SEWAGE DISPOSAL SYSTEM

MARYLAND STATE DEPARTMENT OF HEALTH

A REPAIR

RE: Repair Percolation
10140 Washington Boulevard

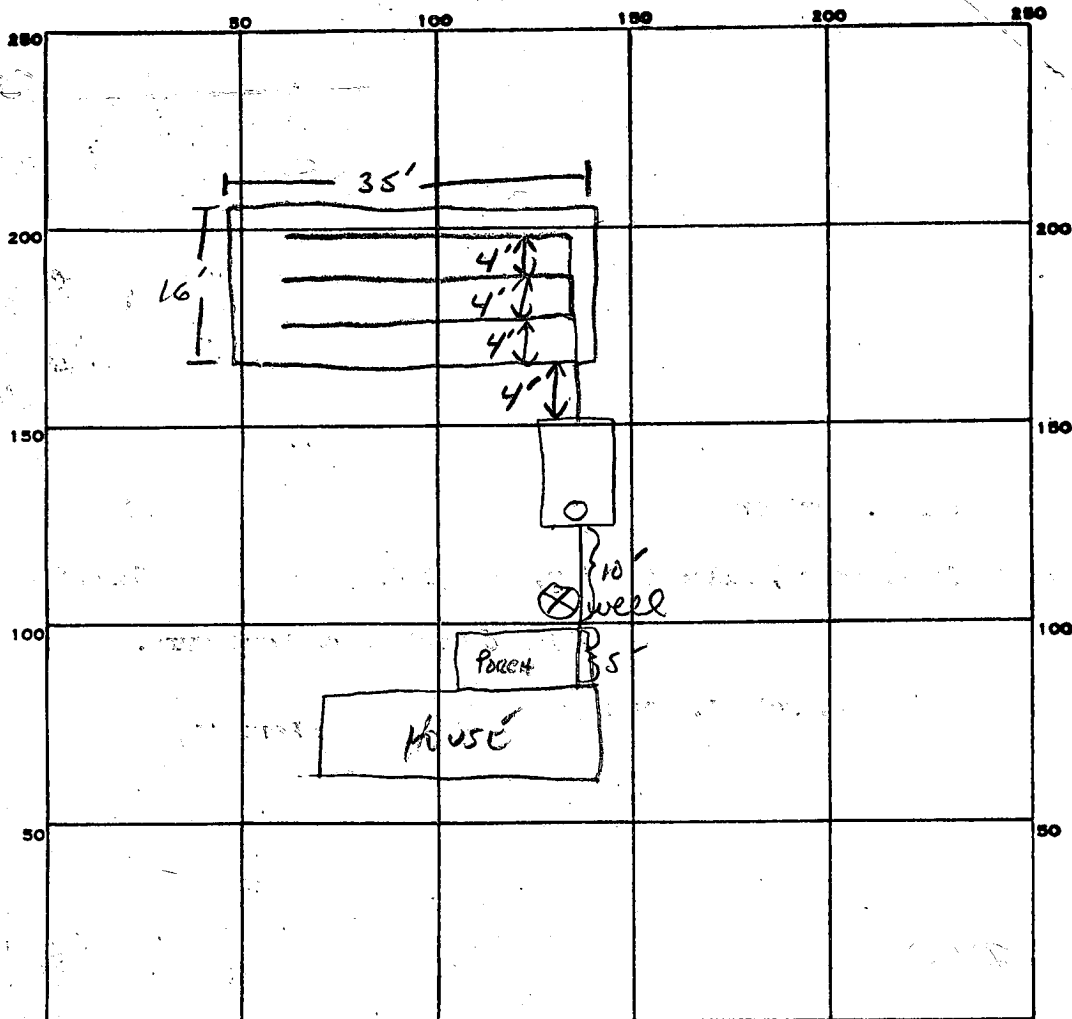
RECOMMENDATION: LEACHING BED, BOTTOM MAXIMUM DEPTH 4.0 FT, INLET AT 2.5 FT, 18 INCHES OF STONE BELOW PIPE. MAKE LEACHING BED 20 FT X 25 FT, BEGIN BED 20 FT FROM BACK OF HOUSE AND 10 FT LEFT OF CORNER OF HOUSE AS SEEN WHEN FACING FROM USI. RUN TRENCH ON LEVEL GROUND TOWARD RIGHT OF HOUSE AS SET WHEN FACING LOT FROM USI. MUST ABANDON PRESENT WELL IN BACK OF HOUSE, AND CONNECT TO COMMUNITY WATER, OWNER STATES "PLANS TO CONNECT TO CITY WATER. SAbel

REMARKS 10 AM 4-11-85 OK TO CONTINUE WORK, Fill well with 5-7' Fill soil, 3 Ft CEMENT AND 2 Ft Fill soil. - Well 12' deep with 3-4' water. Fixture removed from House. Sable

4-11-85 1145 AM OK TO COVER BED AND TANK; 7' Fill to well + 3' CEMENT PLUG + 2' Fill on top. Sable
